# London Road/Abbey Road— RSA Stage 2 Designer Response

For Coventry City Council

LRAR-RSA2-DOC-SM-0001-Rev-01

Fig 2 - New Bus stop location

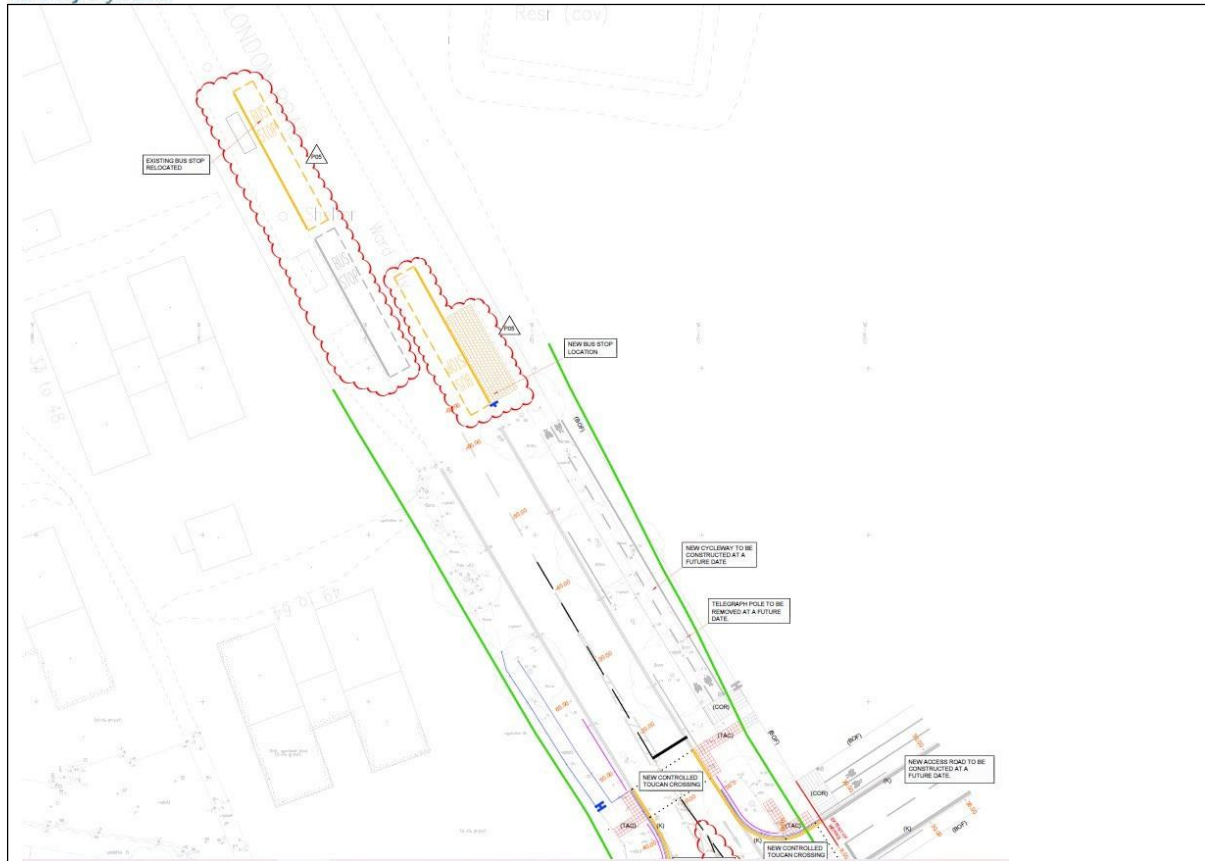
The bus stop relocation is on the approach to the proposed signalised junction and in particular the signal heads. Buses waiting within the bus stop will significantly reduce the conspicuity of the signal heads (for vehicles on the approach from north-west to south-east) and this significantly increases the risk of vehicle to vehicle and vehicle to pedestrian type personal injury collisions.

The designer's response in regards to the stopping distance is noted, however, the audit team still regard the location of the bus stop may result in conspicuity problems. Relocating the bus stop may significantly reduce the likelihood of vehicle to vehicle and vehicle to pedestrian type collisions.

This comment has been accepted. However, discussions have been held with the signal designers and an additional meetings have been held with safety team members and the bus stop co-ordinator for TfWM. Discussions indicated a number of additional locations and measure to be undertaken. There were two further locations for the bus stop explored and discussions on the possibility of the a mast on the southbound approach to the signalisation.

- 1) Yunex, who are the signal designers indicate that the signalisation design is in accordance with design guidance. Given the proximity of the bus stop, they provided 3 primary signals at numbers 5, 6 and 16 (as shown below). Therefore, their view is an additional mast is not appropriate. The designer has accepted this advice.

- 2) The meeting with the safety team suggested a mast if the bus stop was located at 30m from the signal stop line, but also if it was located 40m from the signal stop line. As 1) the additional mast has been reviewed as discussed as the signal design follows current guidance. If the bus stop was located 40m from the stop line, then the adjacent bus stop serving northbound traffic should be relocated as well. There was also a location south of the current bus stop that was considered.
- 3) A further meeting with a representative of TfWM was held. They were happy with the 30m location currently shown. They did not consider the southern option suitable as visibility was not very good. The 40m was considered and TfWM would wish the opposing bus shelter to be relocated as well. The final layout agreed with TfWM is as shown below.

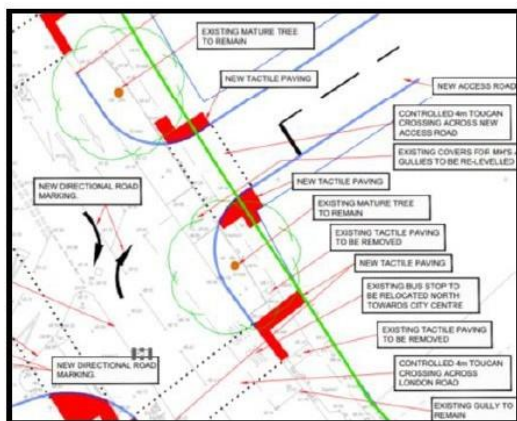
The existing covers are to be re-levelled but will remain in-situ. This location is where a high proportion of vehicles will be turning out of the new access into London Road. Having service covers at/on a corner increases the risk of vehicles skidding and also increases the likelihood of the service covers failing and becoming a maintenance issue. This increases the likelihood of vehicle to vehicle type personal injury collisions.

There are service covers on the proposed cycleway and the designs do not indicate that they will be made cycle friendly. Service covers can make cycling unsafe, particularly in adverse weather conditions; and significantly increases the likelihood of cyclist personal injury.

Examine existing service covers and make the service covers cycle friendly so they do not cause any road safety hazards.

There is a product called GripTop by Saint Gobain, see extract below. This product can be utilised on the covers. This option will be investigated further with the contractor and utility providers.

Fig 4 – Proposed Right Turn Layout

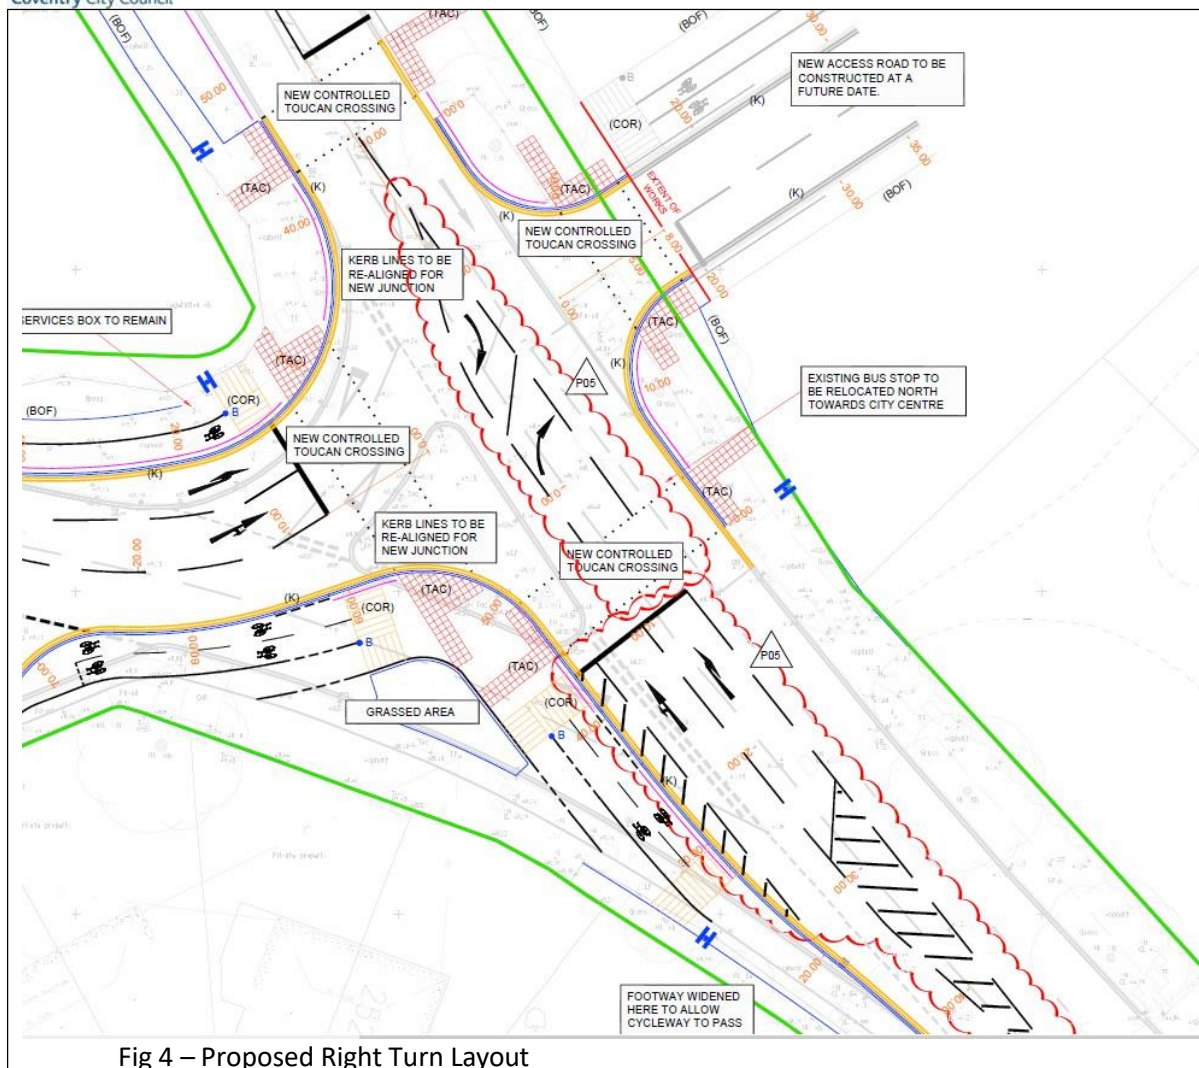
The proposed layout comprises a dedicated left-turn and straight on/right turn configuration on the London Road inbound approach to the new junction. London Road is a high traffic volume route into the city centre, and the proposed lane configuration can result in driver frustration due to traffic queuing behind right turners into the new access. This may result in drivers using the dedicated left-turn lane to manoeuvre through the junction, or try to bypass waiting right turn traffic, and this may result in drivers colliding with left turners and the footway on the north western side of the junction. This significantly increases the likelihood of personal injury collisions related to side swipe collisions and vehicle to pedestrian type collisions.

Redesign the junction layout to consider the impact of the driver frustration related to the lane layout and signal phasing. This will significantly reduce the likelihood of personal injury collisions related to the junction layout.

This comment has been accepted, but it is noted that the junction road markings and layout have not changed from the previous RSA2 and this was not picked up then. As a result, the junction has been reviewed and the proposed layout has been modified as shown below. A dedicated right turn has been included with a central ghost right turn markings to aim decision making prior to the arrival at the junction. Wicket signs will also display the proposed layout to help guide drivers. Additional Linsig modelling is to be undertaken to ensure the right turn capacity is adequate.

Location: London Road - see screen-print

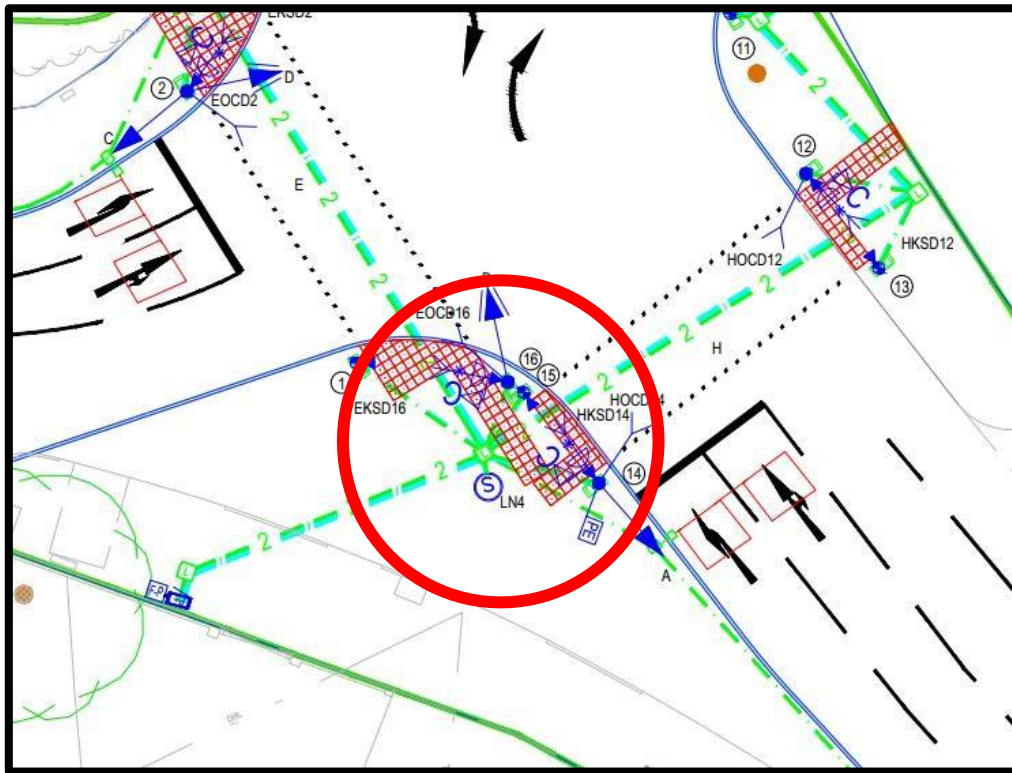
*The bus stop relocation is on the approach to the proposed signalised junction, and in particular the signal heads. Buses waiting within the bus stop will significantly reduce the conspicuity of the signal heads (for vehicles on the approach from north-west to south-east) and this significantly increases the risk of vehicle to vehicle and vehicle to pedestrian type personal injury collisions.*

*The designer's response in regards to stopping distances is noted, however, the audit team still regard the location of the bus stop may result in conspicuity problems. Relocating the bus stop may significantly reduce the likelihood of vehicle-to-vehicle and vehicle to pedestrian type collisions.*

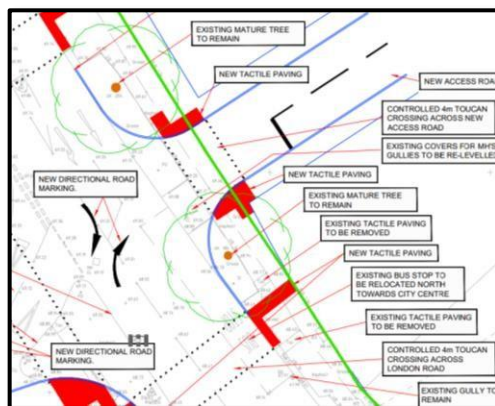
*The submitted drawings are confusing as different drawings highlight different tactile paving layouts for the same locations. As highlighted in the above drawing abstract, the tactile paving has been designed immediately adjacent to tactile paving that is advising pedestrians to travel in different directions. This may result in visually impaired pedestrians becoming confused and entering the highway at the wrong location; and this may result in pedestrian to vehicle type personal injury collisions.*

*If the above extract shows the proposed tactile layout, redesign the tactile paving so that the tactile paving is separated. This will significantly reduce pedestrian confusion and this will significantly reduce the likelihood of vehicle to pedestrian type personal injury collisions.*
